SERVICE BULLETIN

APPLICABILITY: 2014MY and Later Forester
 2008 and Later Impreza, WRX and STI
 2013 and Later XV Crosstrek (EXCEPT Hybrid Model)

NUMBER: 06-46-14

SUBJECT: Revised Brake Light Switch Adjustment Procedure for
 DTCs C1531 and C0054

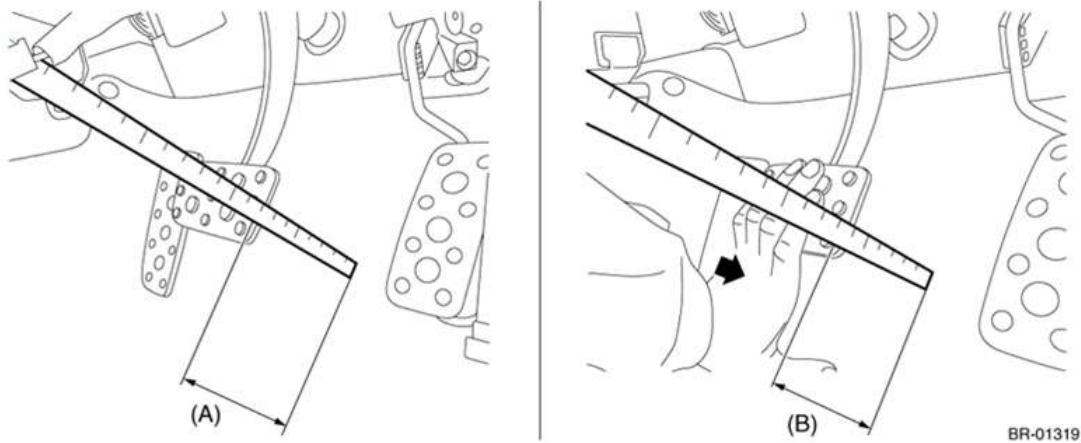
1. Before removing or adjusting the BLS, put a reference mark (a) on the threaded/notched portion as shown in the illustration below.

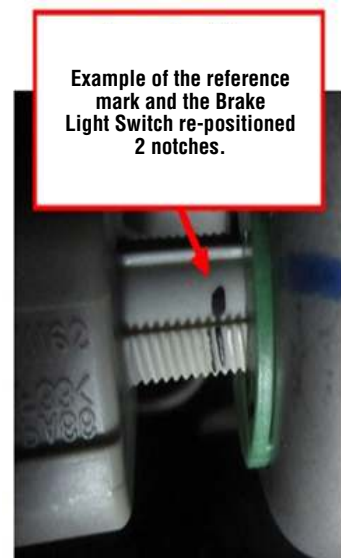
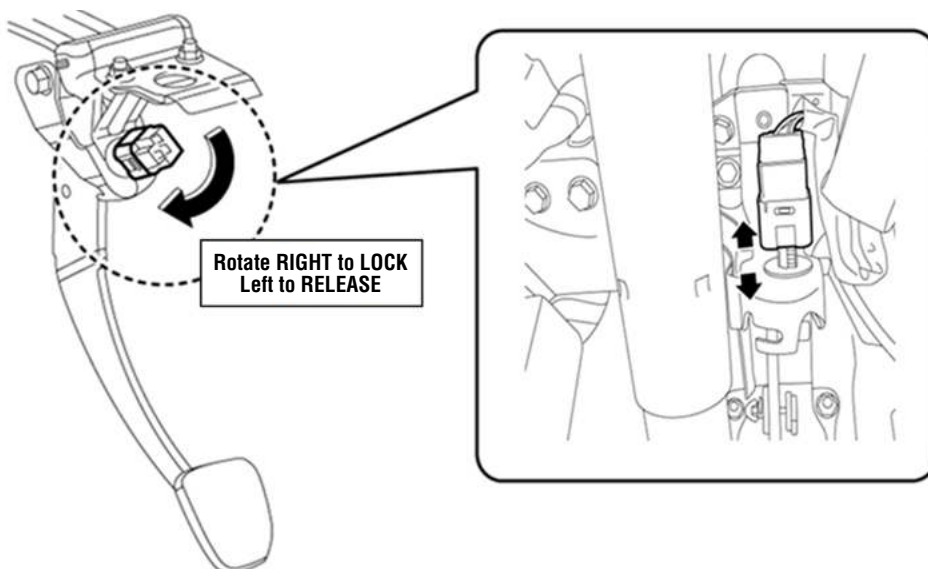
2. As shown in the next illustrations, measure the brake pedal stroke by first measuring the distance “A” between the floor mat and the pedal. Depress the brake pedal slowly until the brake lights come on “B” then record the second measurement. Subtract “B” from “A” to obtain the pedal stroke measurement.

The specification for pedal stroke to activate the BLS is 5.5mm +/- 2.5mm (>3mm but <8mm).

- If the measurement (switch activation) is out of specification, the BLS will need to be adjusted. When the brake lights come on too soon (not enough pedal stroke), the BLS needs to be adjusted “inward” toward the bulkhead while if the pedal stroke is excessive before the brake lights come on, the BLS will need to be adjusted outward toward the steering wheel. The BLS adjustment is sensitive and in most cases, moving it just one notch should bring the operation into specification since one notch is equivalent to approximately 4mm of movement.
